STATE OF MINNESOTA
POLLUTION CONTROL AGENCY

In the Matter of the
Proposed Rule Amendments
Governing the Individual Sewage
Treatment Systems Program,
Minn. R. Ch. 7080

MPCA POSTHEARING
COMMENTS,
May 10, 1999

Hearing Docket: #12-2200-11927-1

7080.0170 subp 1 F, In general. Minnesota Department of Health 3/30/99 letter, comment #15. RR49.12-33 and RR50.1-9 S82 L134.

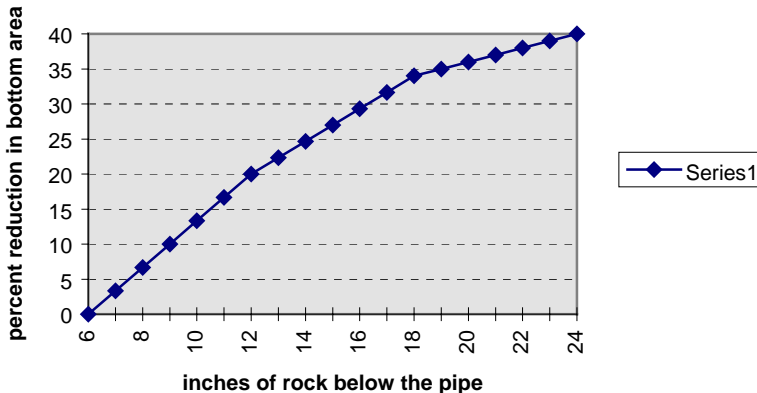
<u>Feature</u>	<u>Sewage Tank, Holding Tank,</u>	<u>Absorption Area or Unsealed Privy</u>	<u>Building Sewer or Supply Pipes</u>
----------------	---	--	---

or
Sealed
Privy

<u>Water Supply</u>	*	*	*
<u>Wells</u>	*	*	*
<u>Water Supply Wells</u>	*	*	*
<u>Buried Water lines</u>	*	*	*
<u>buildings</u>	<u>10</u>	<u>20</u>	
<u>Property Lines***</u>	<u>10</u>	<u>10</u>	
<u>The Ordinary High Water</u>			
<u>Level of Public Waters</u>	<u>****</u>	<u>****</u>

REASON: Correction.
